UNITED STATES PATENT AND TRADEMARK OFFICE

APPLICATION NO.	FILING DATE	FIRST NAMED INVENTOR	ATTORNEY DOCKET NO.	CONFIRMATION NO.
10/720,729	11/24/2003	Gerard A. Rutigliano	893.0011USU	2758

Office Action Summary	Application No. 10/720,729	Applicant(s) RUTIGLIANO ET AL.	
	Examiner Charles E. Cooley	Art Unit 1723

NON-FINAL OFFICE ACTION AFTER RCE

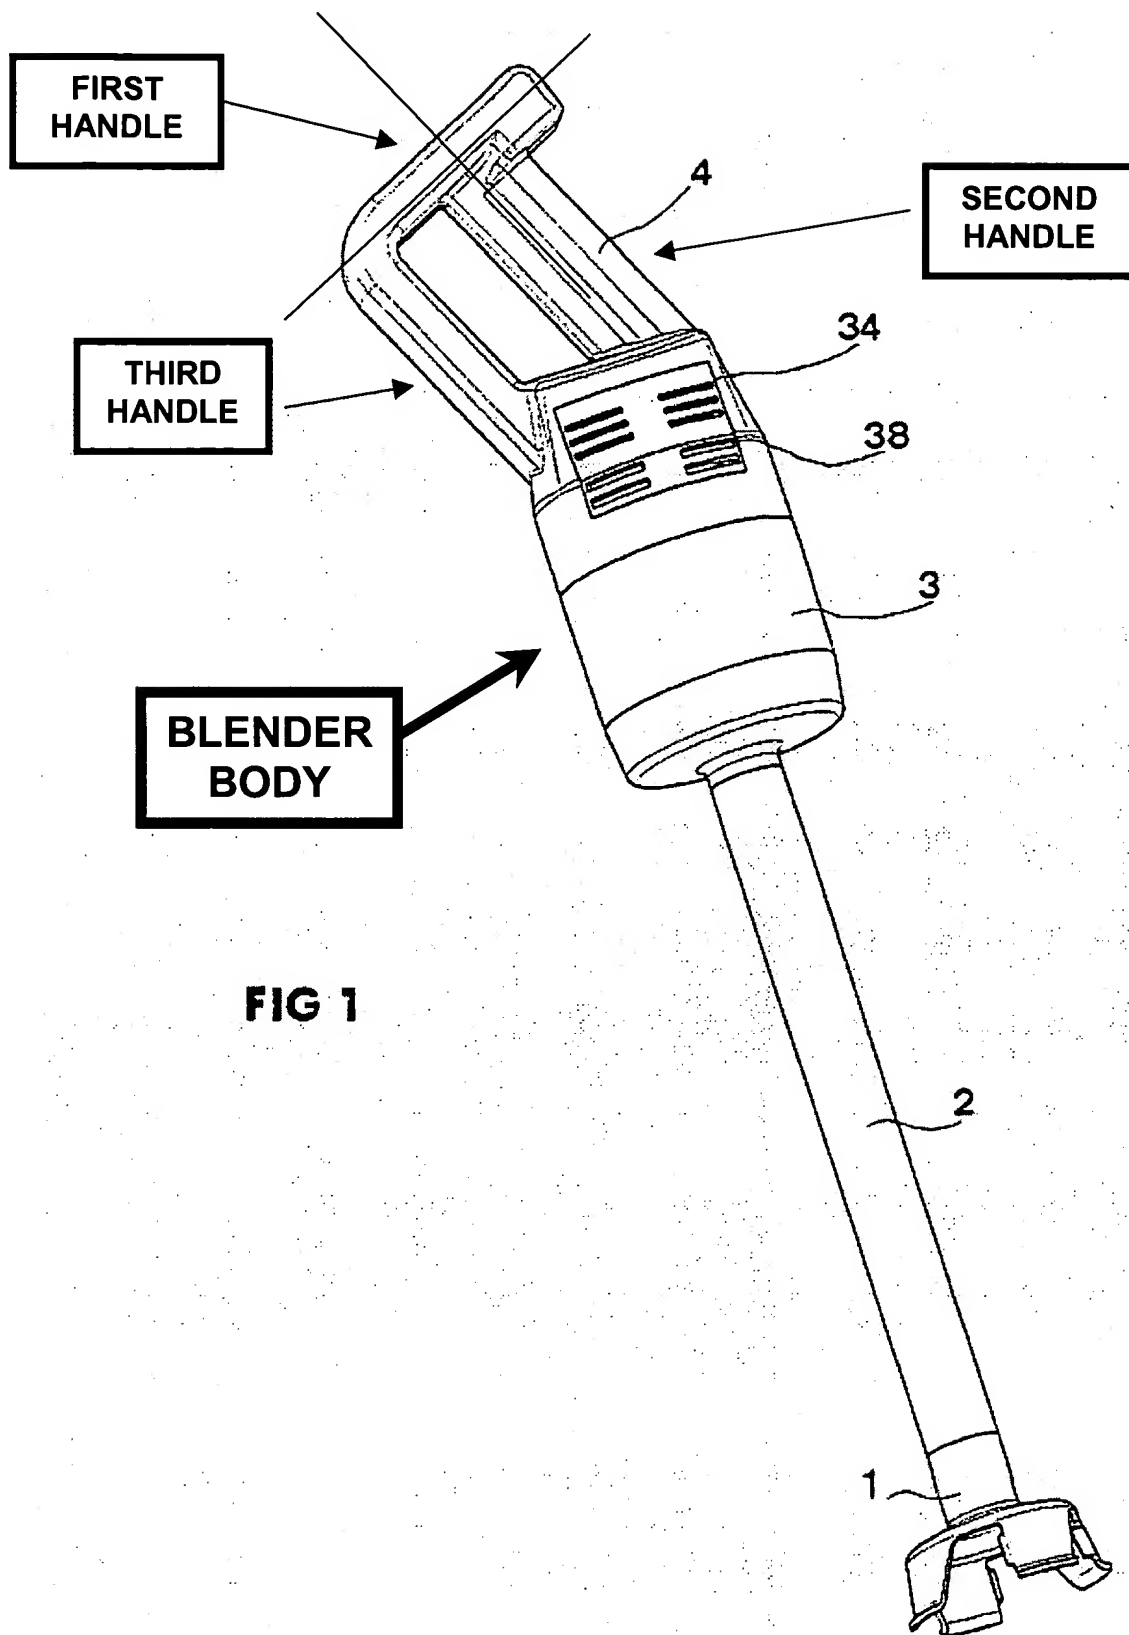
7. **Claims 13-17 and 19-20 are rejected under 35 U.S.C. 102(b) as being clearly anticipated by Calange (US 6,193,404 B1).**

The patent to Calange clearly discloses a blender as seen below comprising a body (the housing seen in Fig. 1) for containing a drive motor 32, the body 3 having a shaped outer surface, an elongated first handle, an elongated second handle, and an elongated third handle as labeled below, the handles accommodating the palm of a user's hand; a drive shaft 5 operatively connected to said drive motor 32, and a tool 13

operatively connected to said drive shaft; wherein said first handle is elongated with a proximal end portion, a central portion and a distal end portion; wherein said proximal end and said distal end enable an operator's hand to easily grasp or wrap thereabout; a central portion of the top section of the first handle is connected to the second handle 4 (Fig. 1); wherein said second handle 4 can be handled by the operator to stabilize the immersion blender during operation; the first handle having a section disposed on a side of said body 3; the handles being capable of being disposed at any orientation with respect to a working surface; the third handle 3 is disposed on a side of the body (Fig. 1). As seen below, the first handle is disposed in a substantially perpendicular orientation with respect to the second handle and intersects the second handle at a center region thereof.

The examiner believes any part of a blending device that can be grasped by a user (such as elements denoted as handles, any projections from the motor housing, or an outer surface of the motor housing itself, etc.) can be considered a "handle" within the broad scope of the pending claims. Simply because an element has another function, there is no evidence that such an element could not be used or is wholly incapable of being implemented as a handle by an operator. With this not unreasonable approach, at least four handles can be identified on the device of Calange. Accordingly, with further regard to Calange, the multiple elements on the top of housing 3 can be considered discrete handles as pictured above, contrary to Applicant's assertion.
